FOREST LAKES FILING NO. 6

CONSTRUCTION PLANS

EPC STORMWATER REVIEW COMMENTS
IN ORANGE BOXES WITH BLACK TEXT

FOREST LAKES FILING NO. 6 CONSTRUCTION PLANS TITLE SHEET			
DESIGNED BY	MAL	SCALE	DATE 08/04/2020
DRAWN BY	MES	(H) 1" = N/A	SHEET 1 OF 25
CHECKED BY		(V) 1" = N/A	JOB NO. 1175.60

FOREST LAKES FILING NO. 6
GRADING AND EROSION CONTROL PLAN

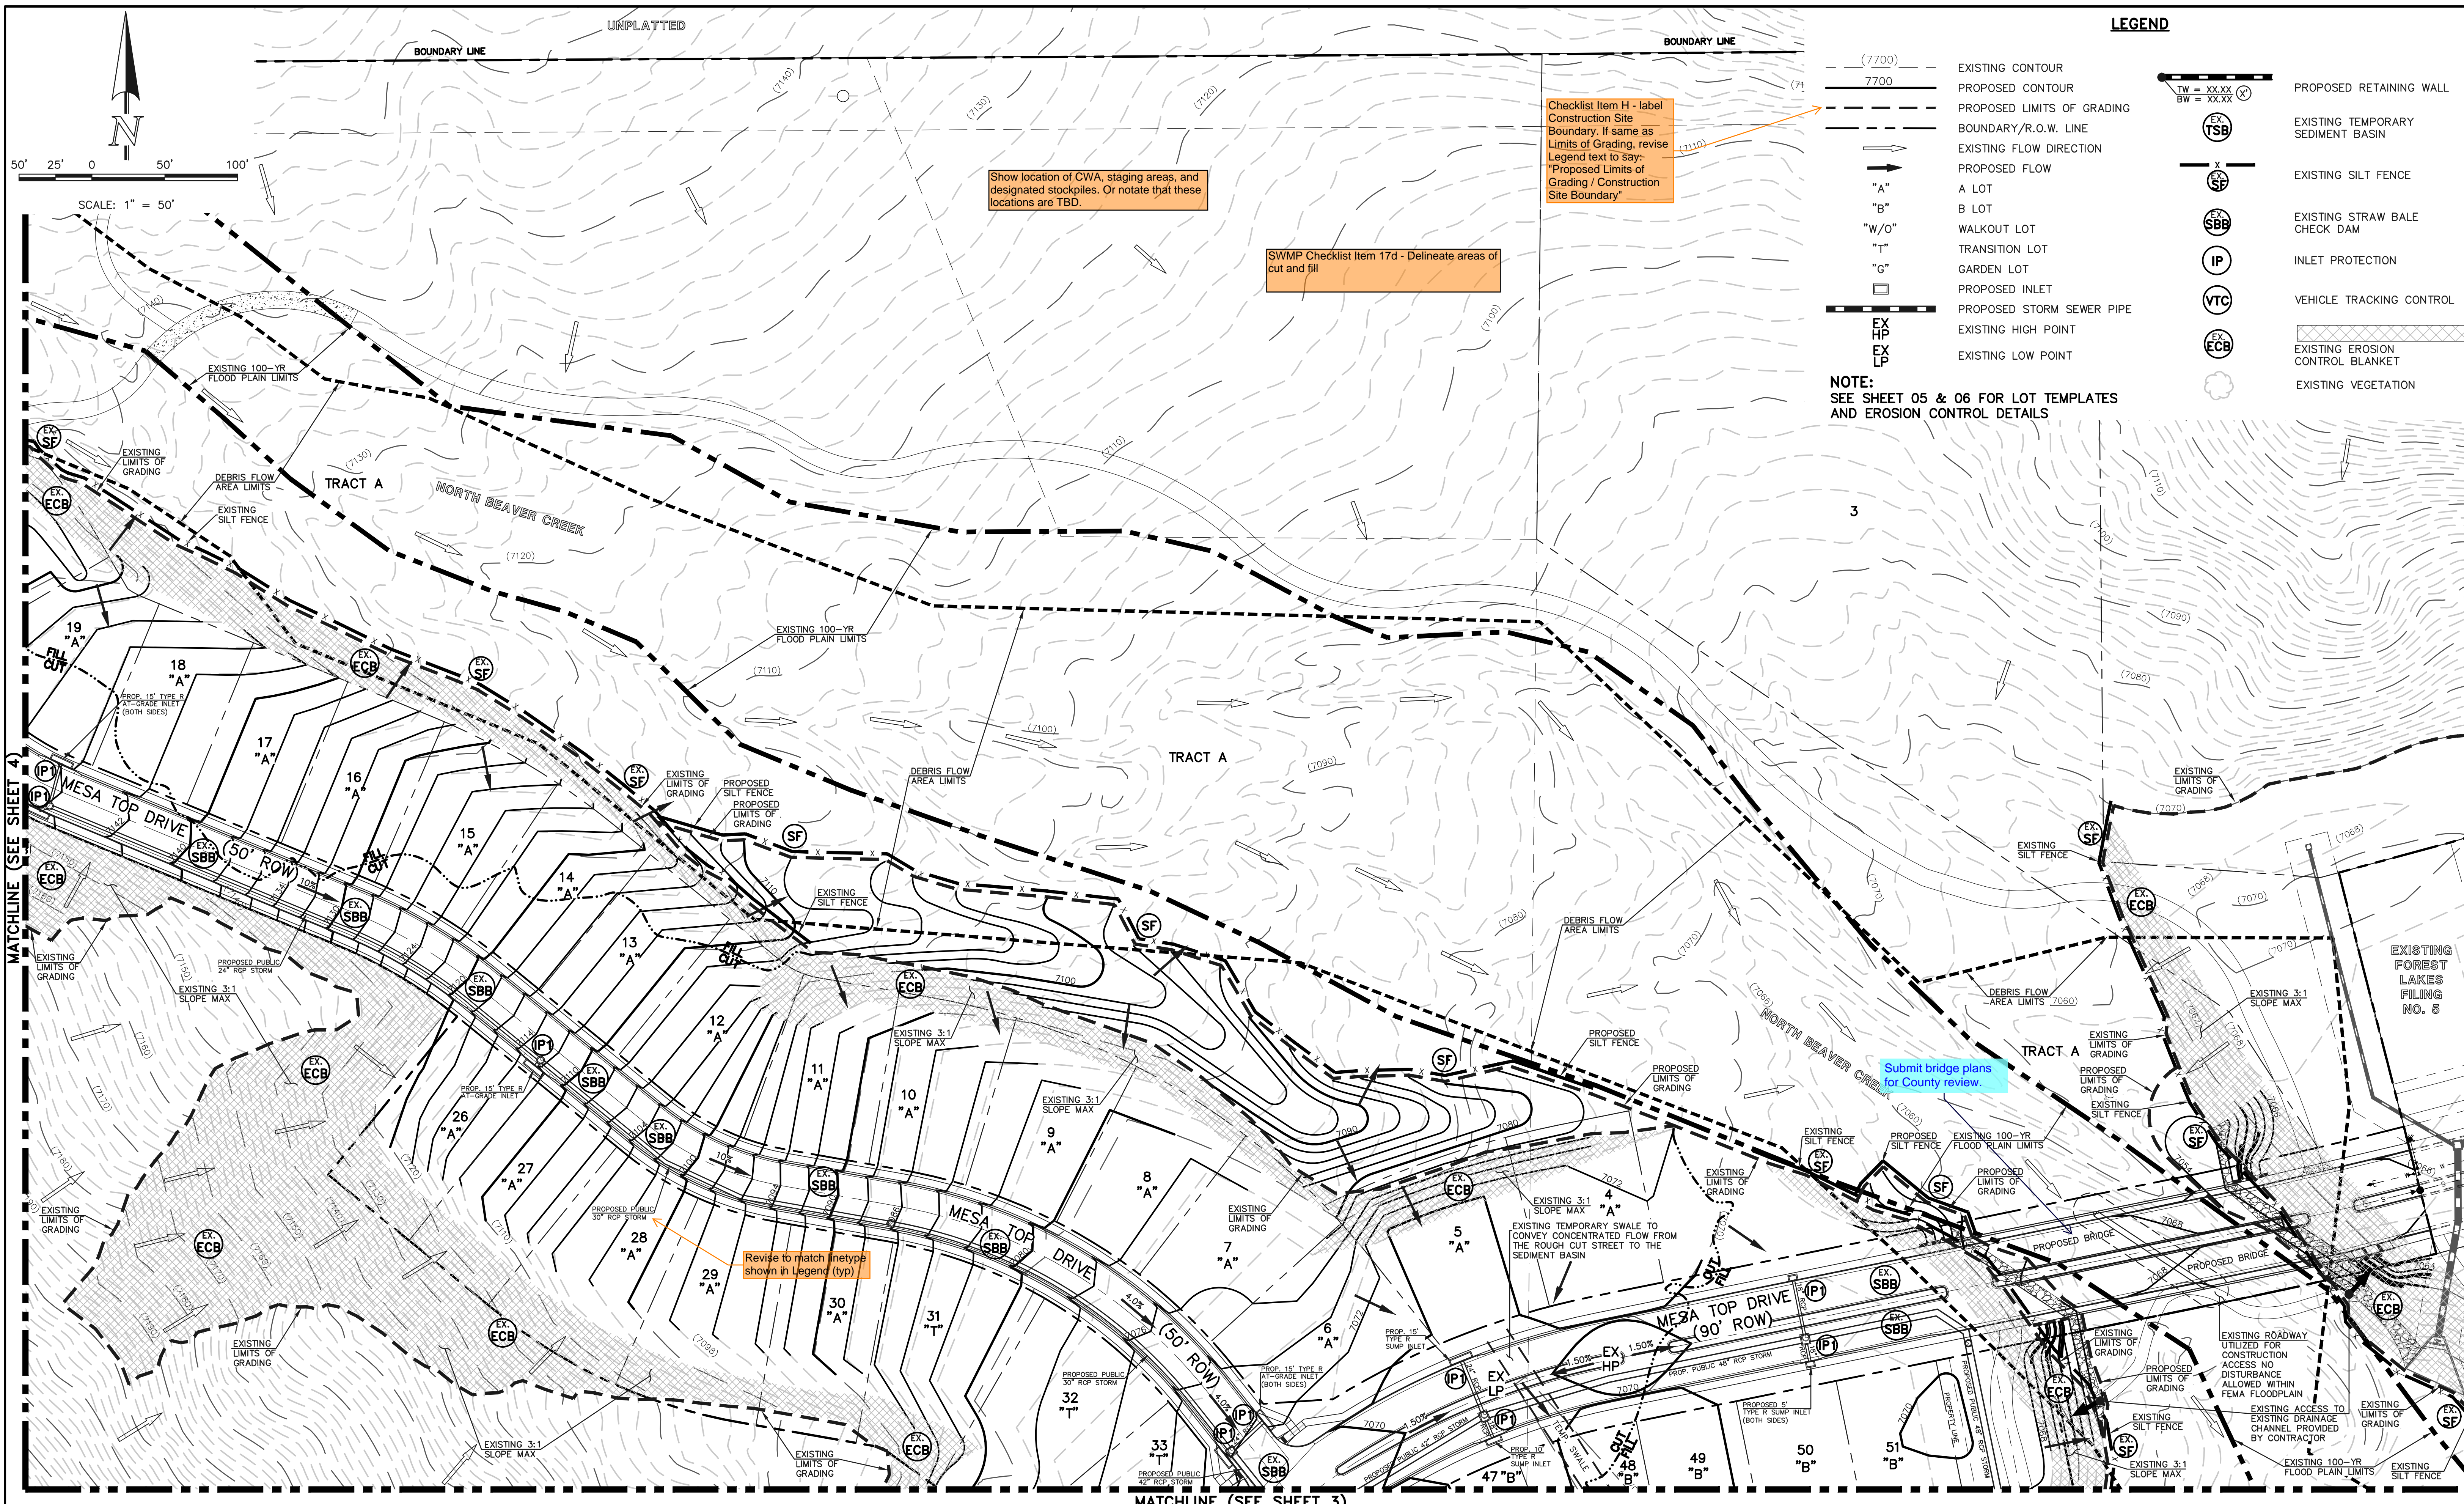
Checklist Item H - label Construction Site Boundary. If same as Limits of Grading, revise Legend text to say: "Proposed Limits of Grading / Construction Site Boundary"

Show location of CWA, staging areas, and designated stockpiles. Or note that these locations are TBD.

Submit bridge plans for County review.

Revise to match in type shown in Legend (typ)

GRADING AND EROSION CONTROL PLAN

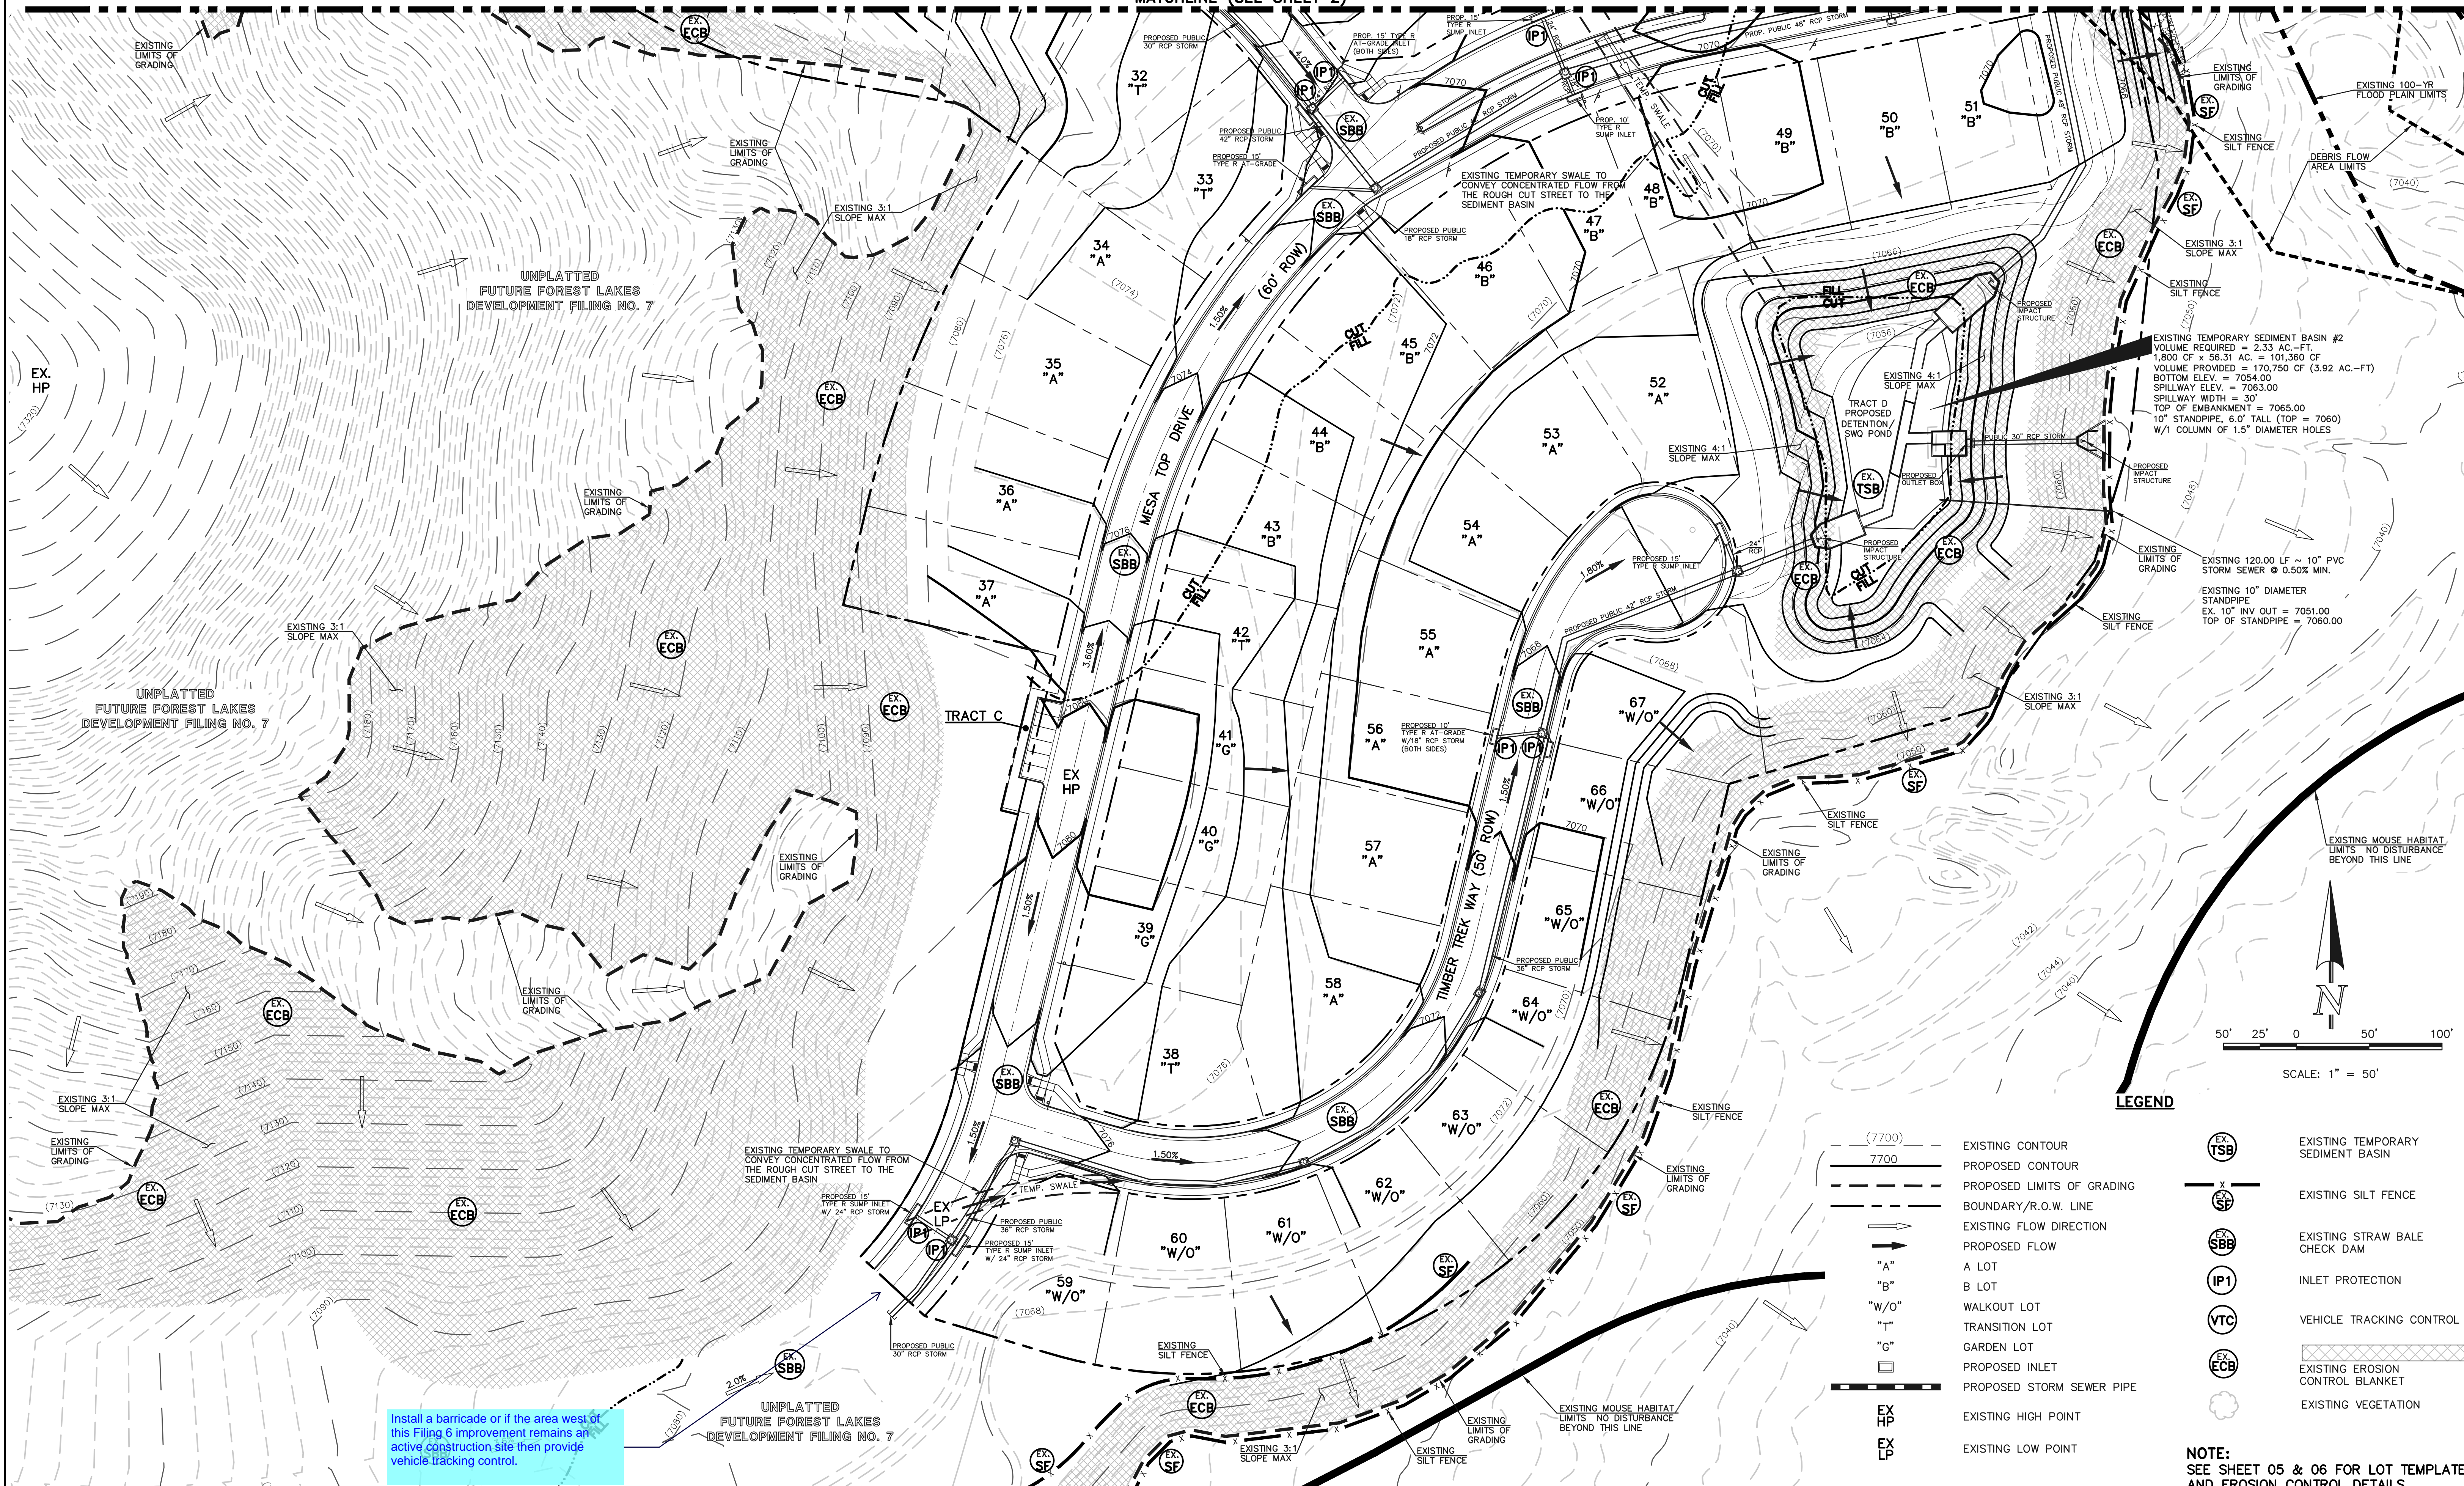
Install a barricade or if the area west of this Filing 6 improvement remains an active construction site then provide vehicle tracking control.

GRADING AND EROSION CONTROL PLAN

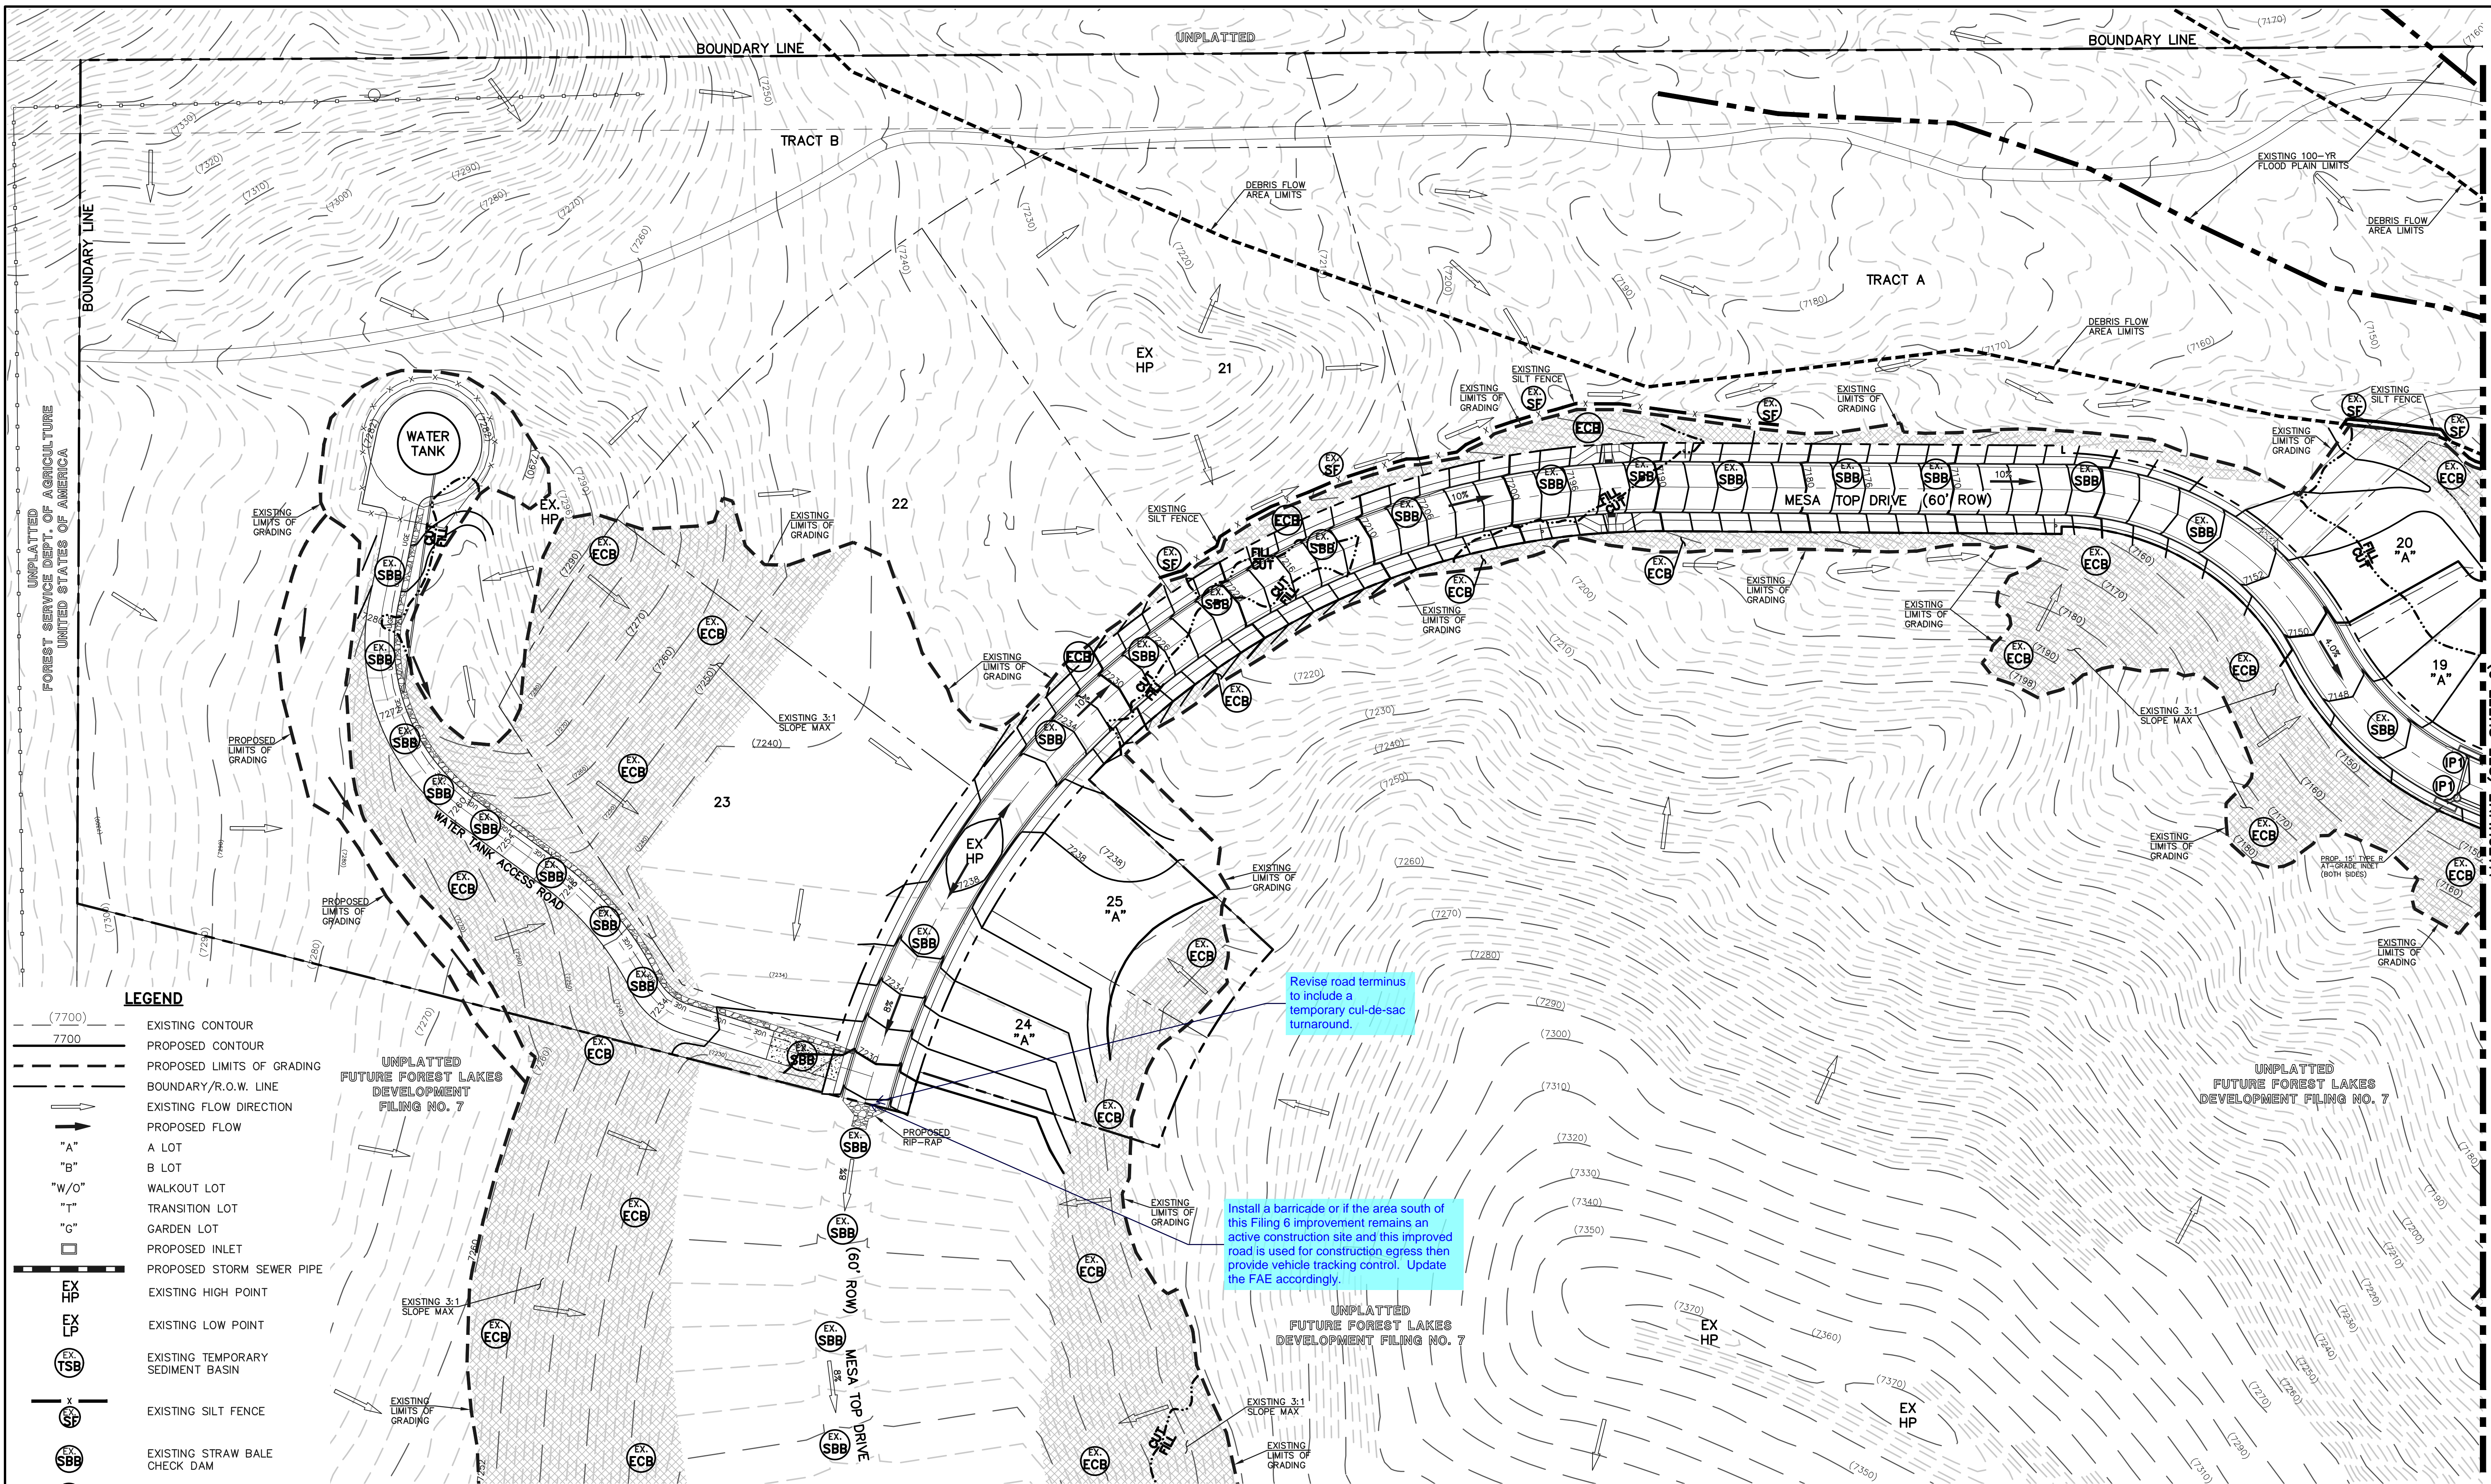
Revise road terminus to include a temporary cul-de-sac turnaround.

Install a barricade or if the area south of this Filing 6 improvement remains an active construction site and this improved road is used for construction egress then provide vehicle tracking control. Update the FAE accordingly.
